STATUS CHECK	Commercial Building Permit	Application # 13-128268-REV-01-CO
Status Date: August 01, 2013		IVR Number: 3347854

PROJECT INFORMATION	Description of Work: REVISION-CHANGE DOOR LOCATION FROM BOTTOM OF MEZZANINE STAIR TO LANDING AT TOP OF STAIR PER APPEAL
Street 424 SW 4TH AVE	
Address

Permit Revision Application and Submittal Requirements

witherspoon Building
Tenant Improvements
424 SW 4th Ave
Portland, OR 97204

**MEZZANINE
FLOOR PLAN**

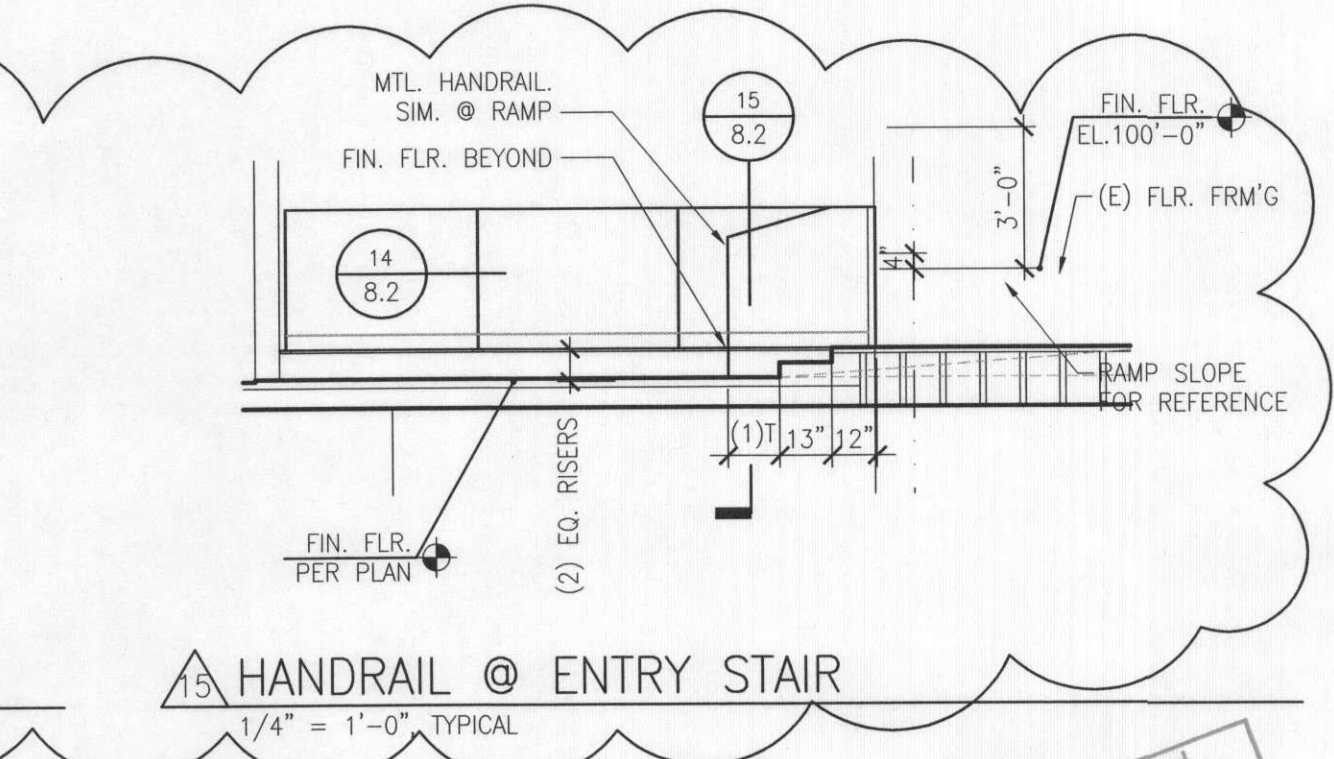
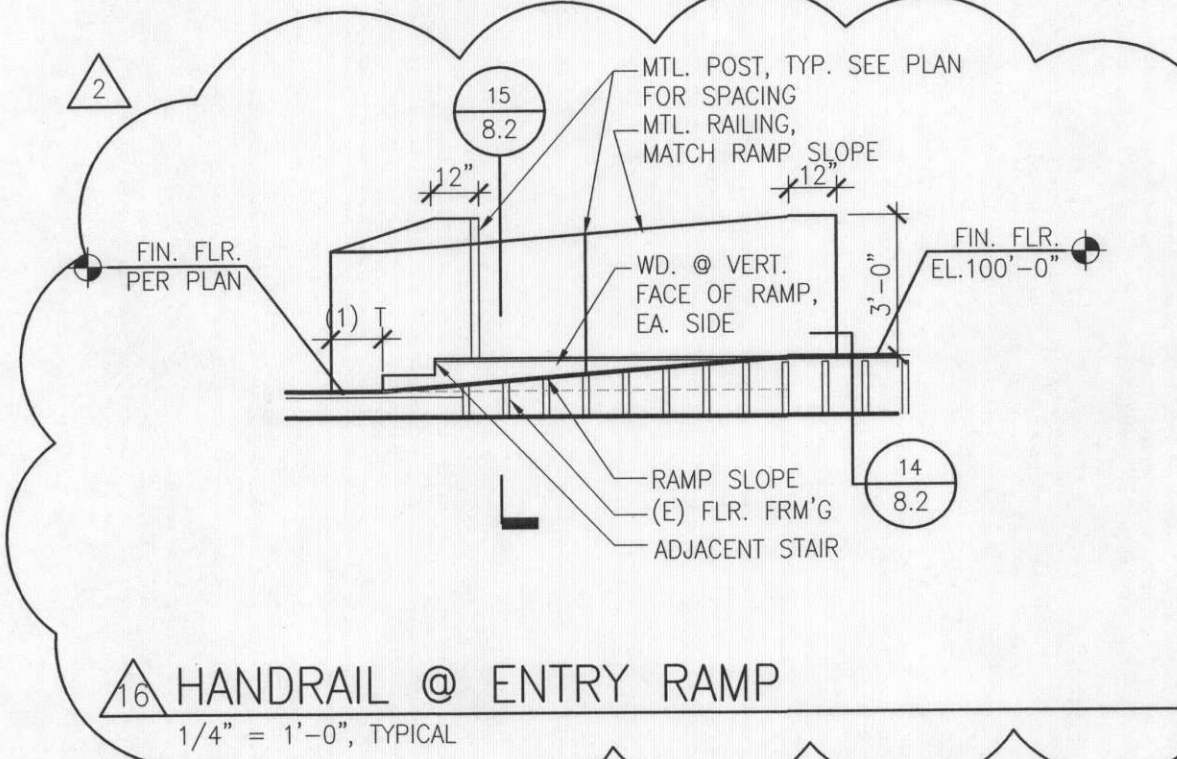
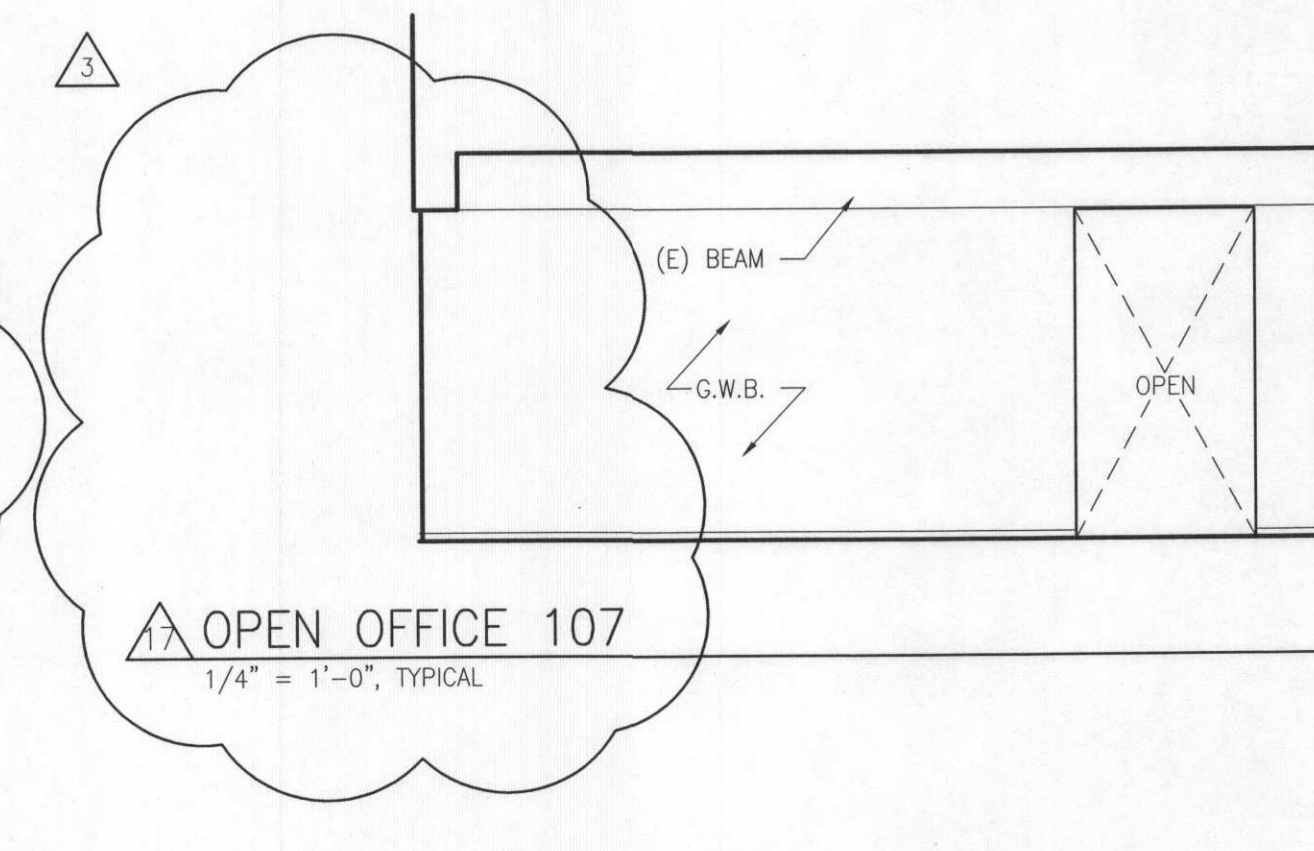
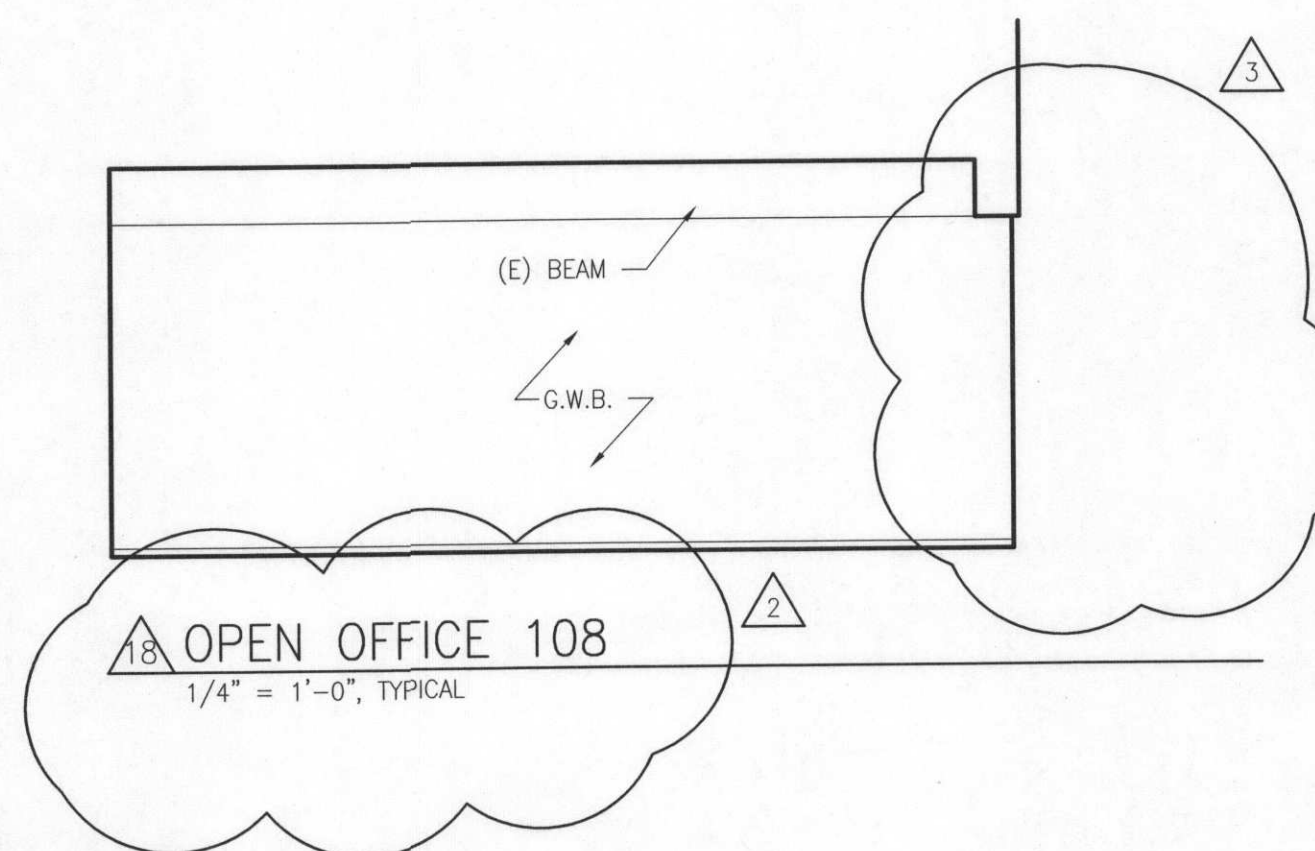
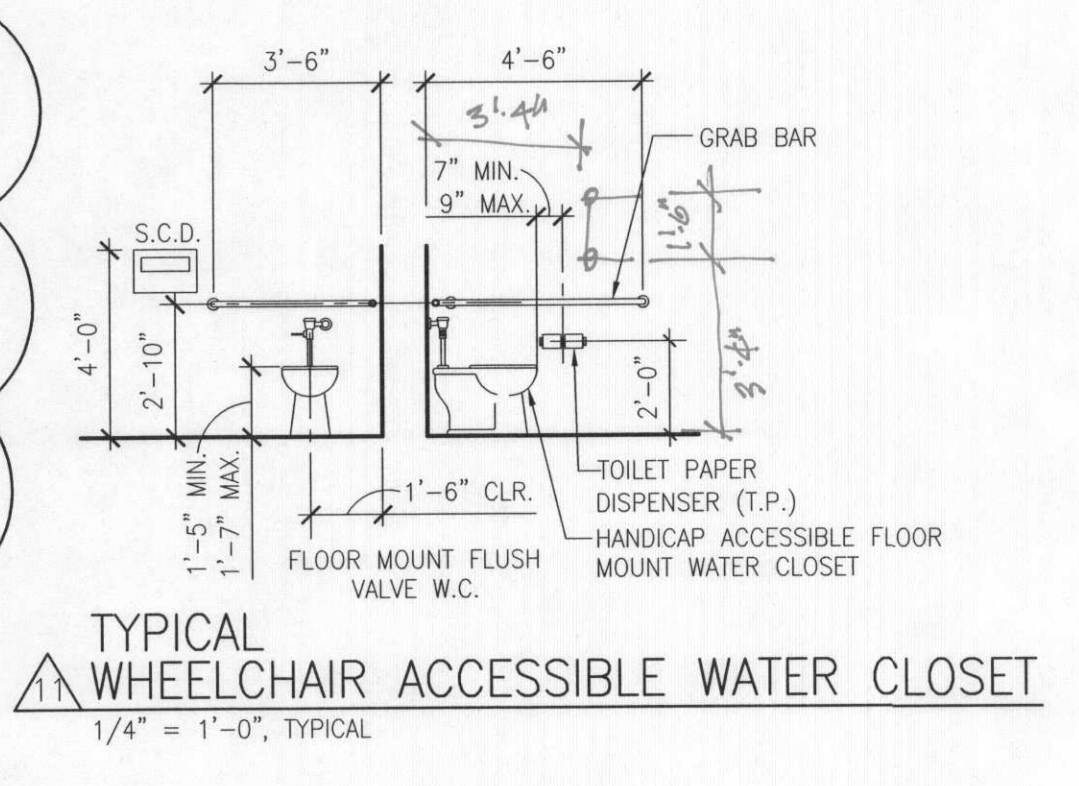
DOOR LOCATION CHANGE FROM BOTTOM OF MEZZANINE
STAIR TO LANDING AT TOP OF STAIR.
